UNITED STATES
NUCLEAR REGULATORY COMMISSION
WASHINGTON, D. C. 20555

FACILITIES: Shoreham Nuclear Power Station Unit No. 1, Limerick
Generating Station Units No. 1 and No. 2, William H. Zimmer
Nuclear Power Station, Unit 1, Bailly Generatin Station
Nuclear No. 1, LaSalle County Station Units No. 1 and No. 2,
Susquehanna Steam Electric Station Units No. 1 and No. 2,
WPPSS Nuclear Project No. 2, Nine Mile Point Nuclear
Station Unit No. 2.

SUBJECT: SUMMARY OF MEETINGS HELD ON DECEMBER 2, 1976 TO DISCUSS
MARK II CONTAINMENT STRUCTURAL DESIGN AND POOL DYNAMIC
LOADS SUPPORTING PROGRAM

Fig. 4

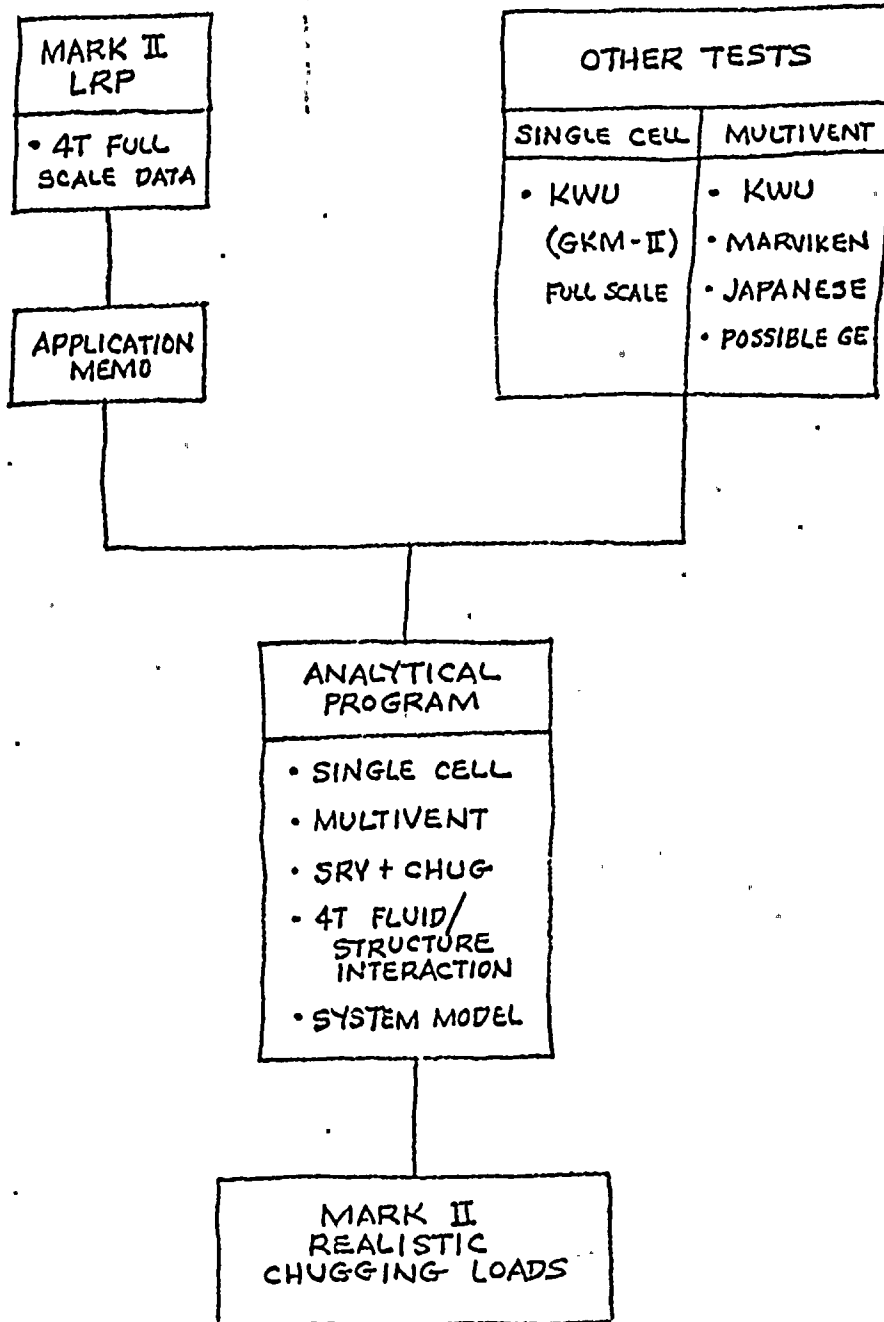
The program for defining the steam loads (chugging loads) developed by the Mark II owners consists of a parallel analytical and experimental approach. GE stated their analysis indicates that the single cell tests provide the bounding chugging load. Therefore, the objective of their chugging program will be to first confirm the conservatism of the single cell approach and then to develop a more realistic predictive method for individual plants (Fig. 4).

The overall chugging program technical strategy (the analytical and experimental program) is shown on Fig. 4. The analytical approach is to develop an analytical model from first principles and to compile and use all known experimental data to verify and refine the model. As a parallel effort GE is planning a multi vent test and has started the acquisition of equipment. However, they expect that their analytical approach will resolve the chugging problem and they do not expect to have to run the multi vent tests. The decision on whether to proceed with the tests will be made in January. The analytical program is a Mark I and Mark II owners jointly funded program. The current status of the program is shown in Fig. 5.
